Harwich Planning Board Agenda  
**Tuesday, January 26, 2021 – 6:30 PM**  
Town Hall, 732 Main Street, Harwich

**AGENDA ITEM # IIA**

To: Planning Board  
From: Charleen Greenhalgh, Town Planner  
Date: January 19, 2021  
Re: Staff Report – Site Plan Review & Use Special Permits

**PB2020-33 Main Street Stone Horse, applicant & owner**, c/o William F. Riley, Esq. representative, seeks a new Use Special Permit, to convert one of the two dormitory buildings, specifically the building known as 868 Route 28, into twenty two (22) one-bedroom apartments and to amend the previously approved Site Plan Review Special Permit granted under case PB2019-13 with additional parking requirement and other waivers. The application is pursuant to the Code of the Town of Harwich §325-51.Q (Multifamily Use) and §325-55 (Site Plan Review). The property is located 872 Route 28, Map 25, Parcel A2, in the CH-1 zoning district.

**SITE PLAN**  
 Harwich (South), Massachusetts  
 Description of Revision  
 Date  
 2021-01-10  
 Rev. #  
 1  
 See Page 2 of List of Revisions

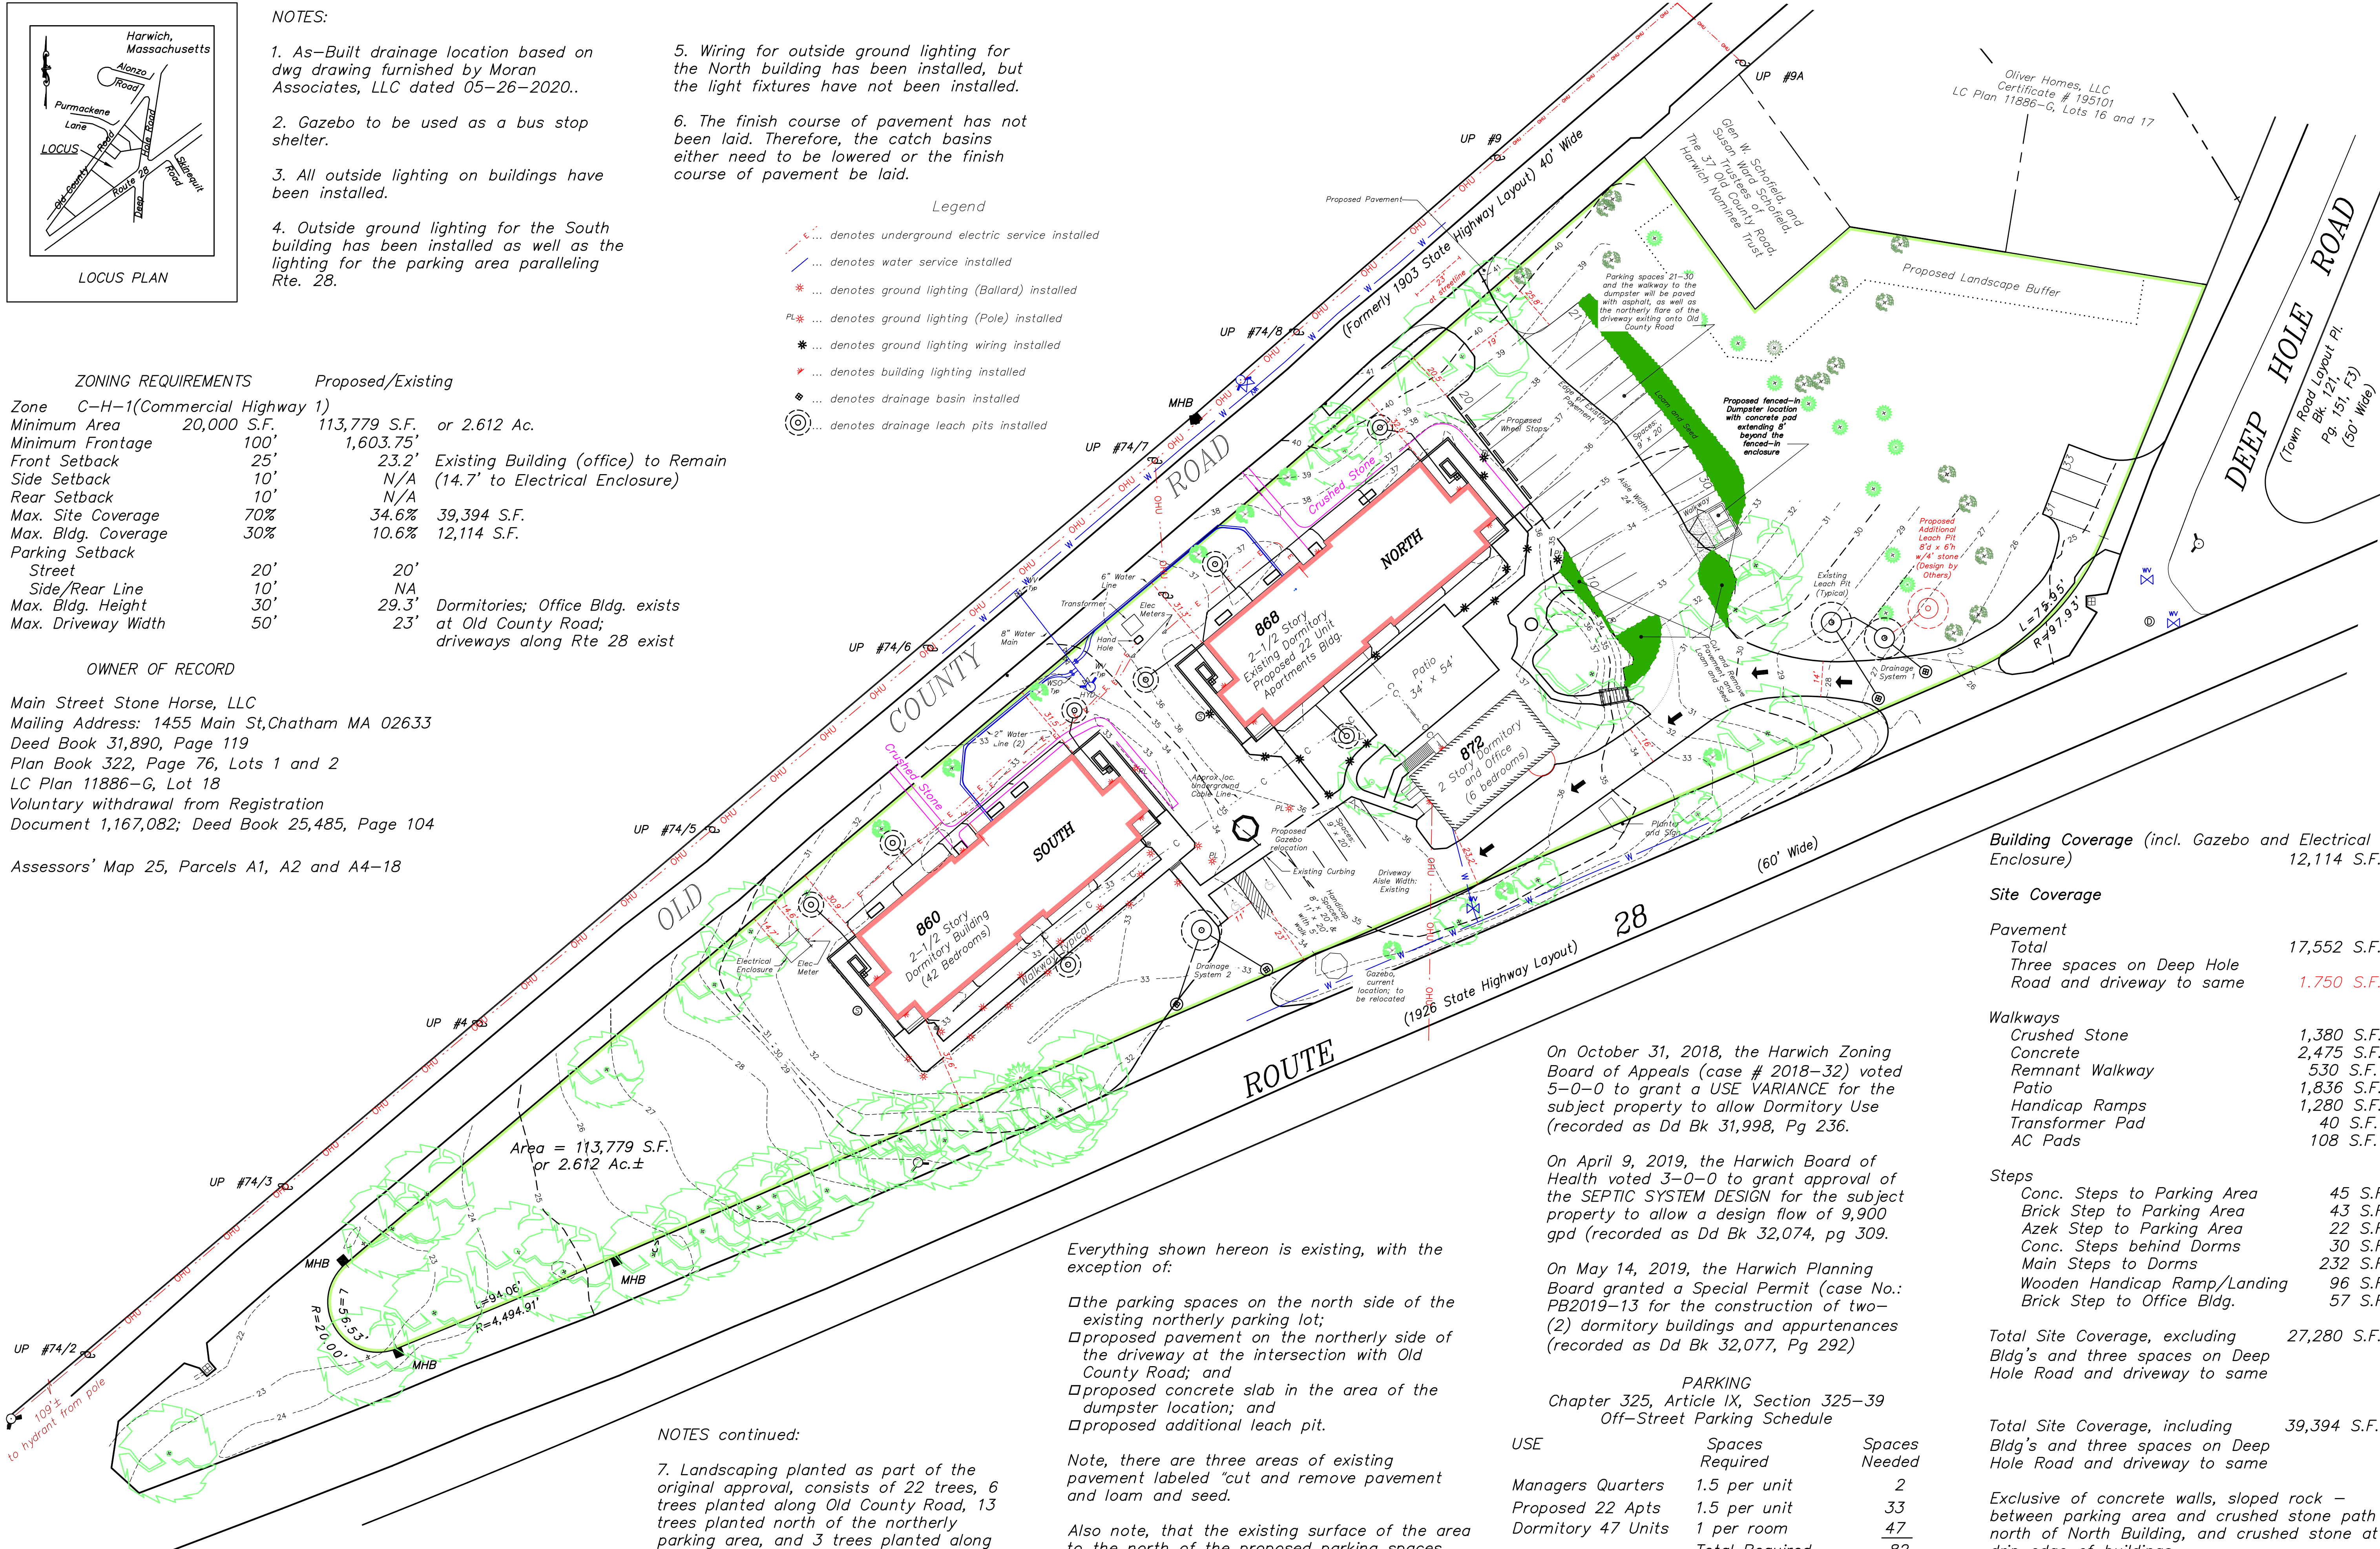
- c) Regarding the parking spaces and driveway along Deep Hole Road. Again, it is the responsibility of the applicant and/or the representatives to provide a reason why these should be allowable. As stated previously, Staff cannot support these three parking spaces or the drive.

- d) A statement has been made that *“I have also added the width of the driveway exiting the northerly parking area to Old County Road, which is a foot wider than previously approved, 19’ vs. 18’, as well as the narrowest widths of the driveways that served the original Stonehorse Motel.”* Staff believes that this needs to be 24’ wide. When it was one row of parking, the reduced width was like adequate.

- j) New waiver #4 – We do not understand the request.
- k) A statement was made that the *“lot coverages have been amended to address the new parking areas and any other site changes, see the plan of Site Coverage Area Calculations that was originally filed by the attorney”*. We cannot be responsible for discerning which plans were superseded and which were not. All relevant and necessary information must be on the site plan.

- q) We need a true surveyed existing conditions plan of exactly how the site exists today. We then need a site plan of what is proposed. We have made the suggestion that it be superimposed over the existing plan for clarity.

**ORTHO PHOTO PLAN**

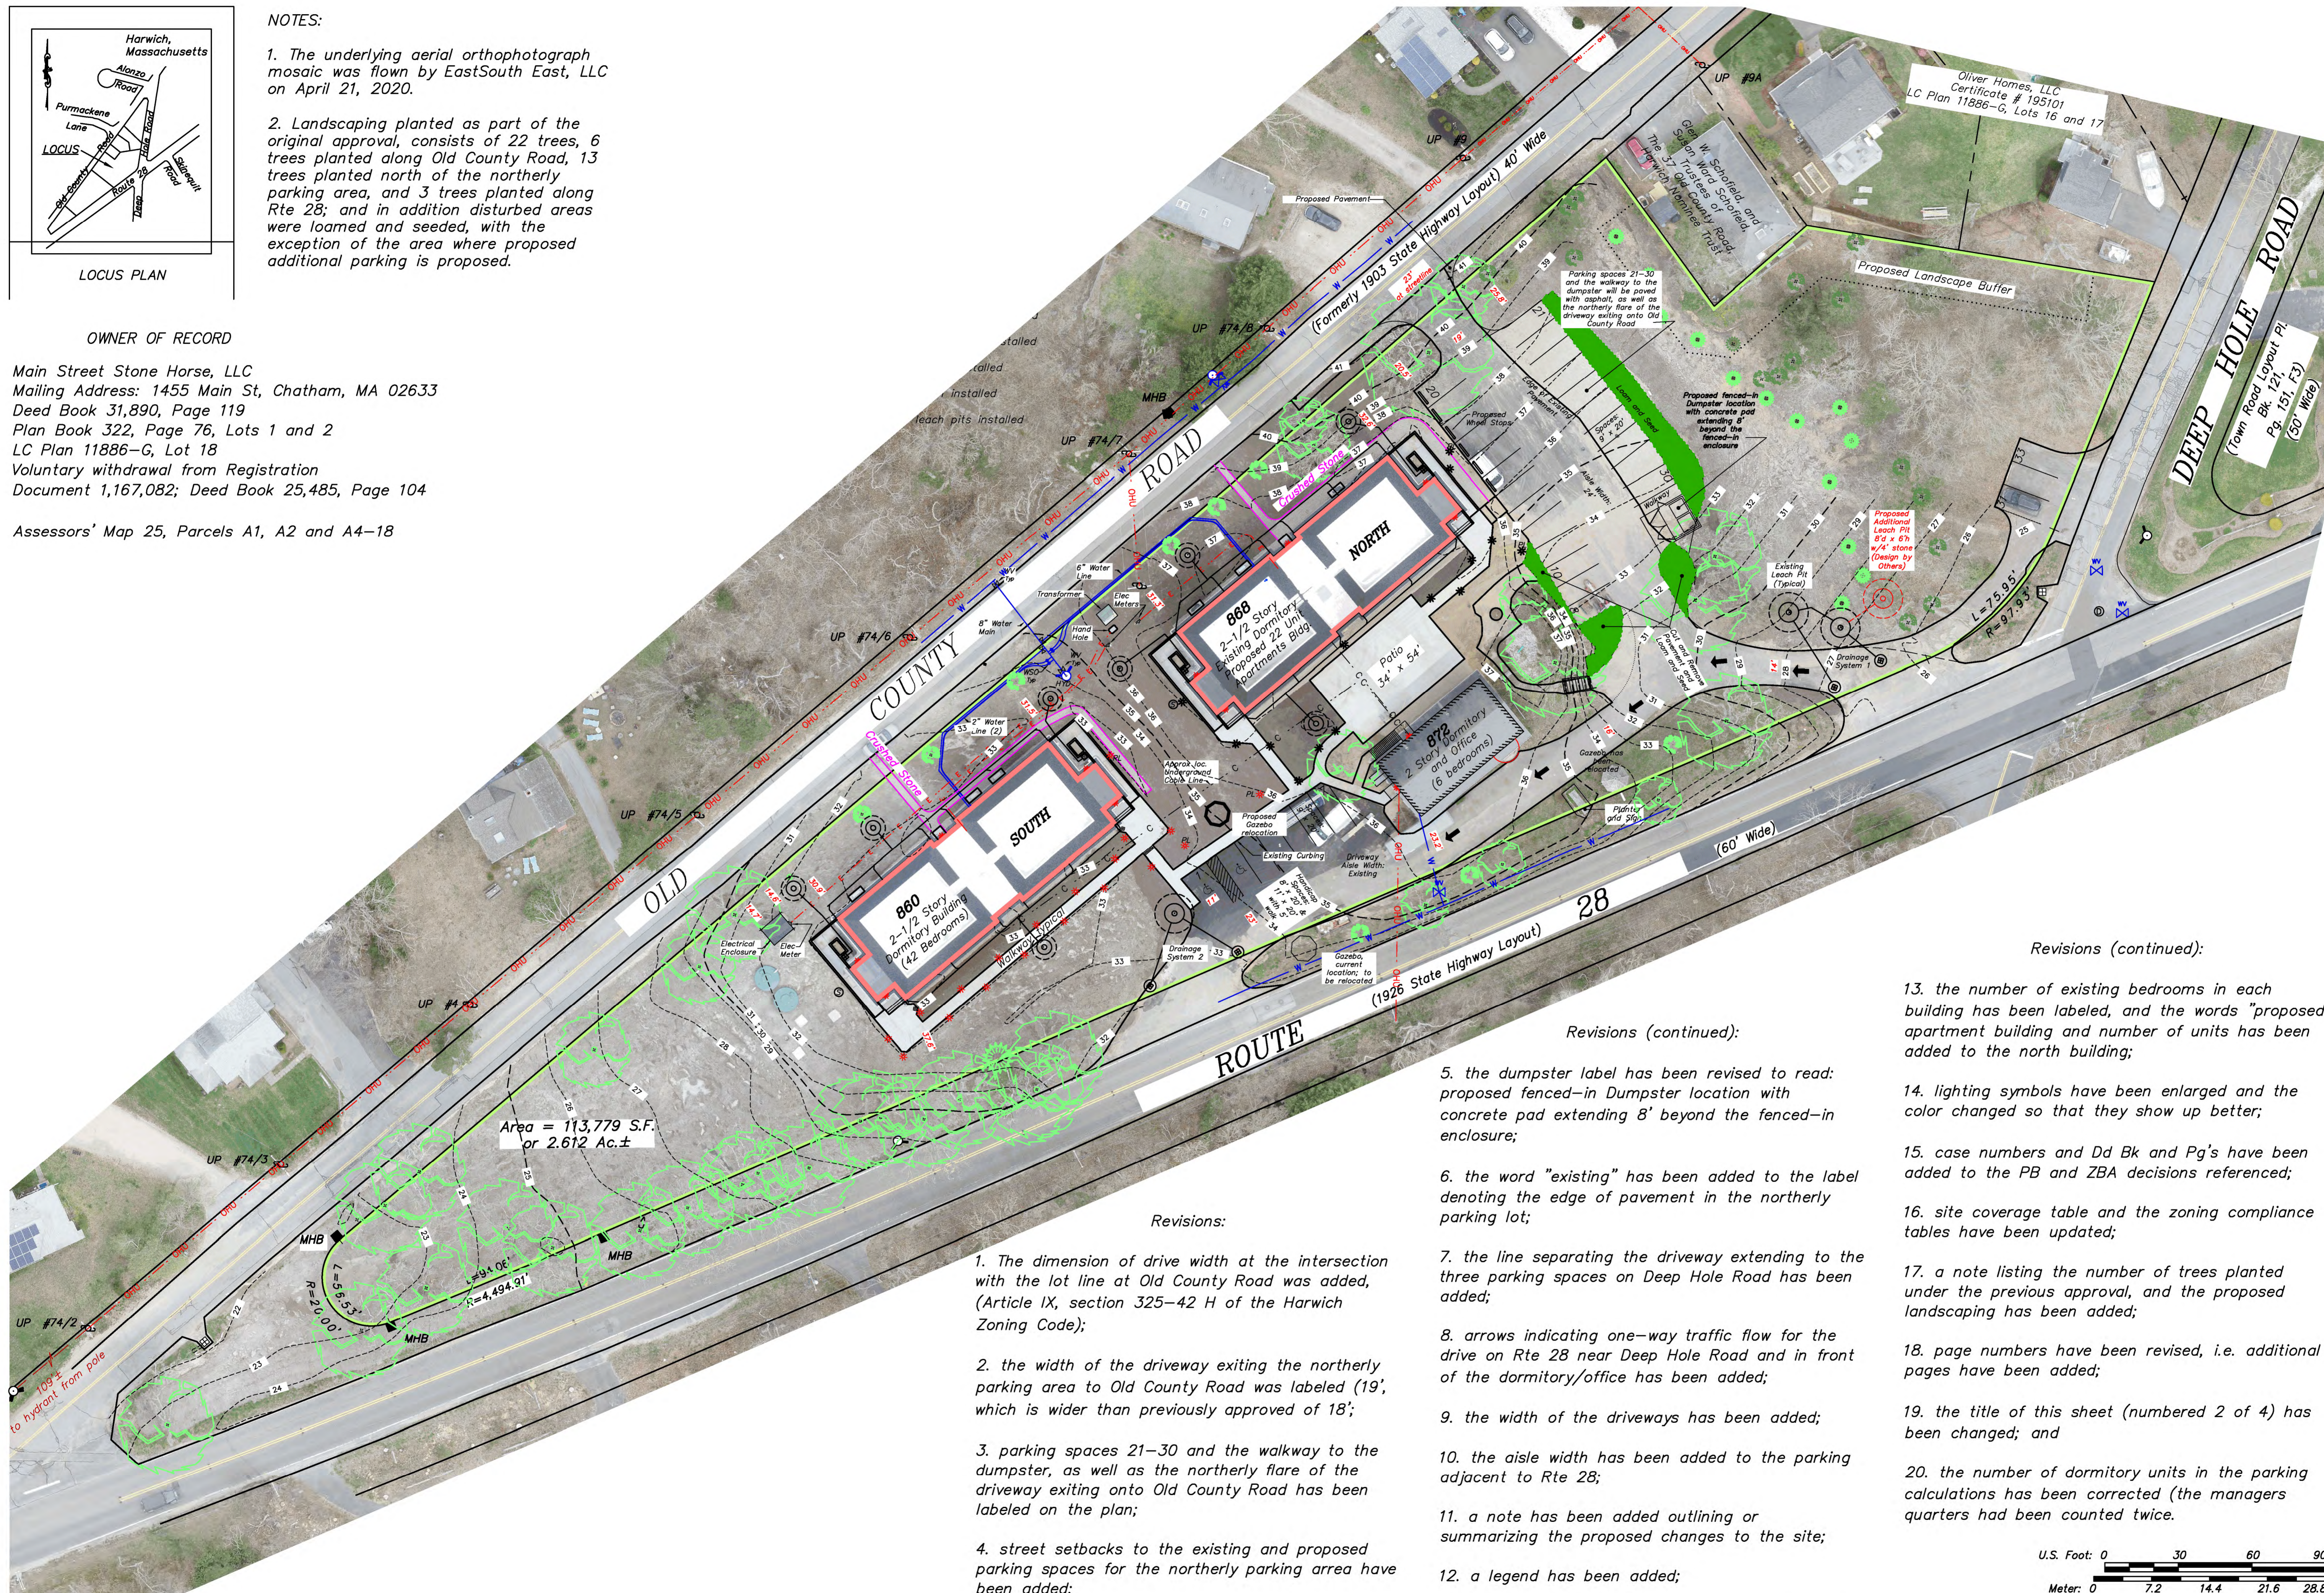
- e) As stated previously, an existing conditions plan showing what exists on the ground today is required. The orthophoto plans are not sufficient, nor are the added notes stating that *“Everything shown hereon is existing, with the exception of:”* and the corresponding four item.

- l) As stated previously the orthophoto plans are not necessary or relevant to the application.
- m) The parking area containing the 7 parking spaces along Route 28 is intended to be 2-way traffic, however this is adjacent to a 1-way drive. How will a vehicle turn around with this new configuration? The approved plan provided an ADA parking spaces at the northeasterly end, the hatched area served as an available area to turn around.
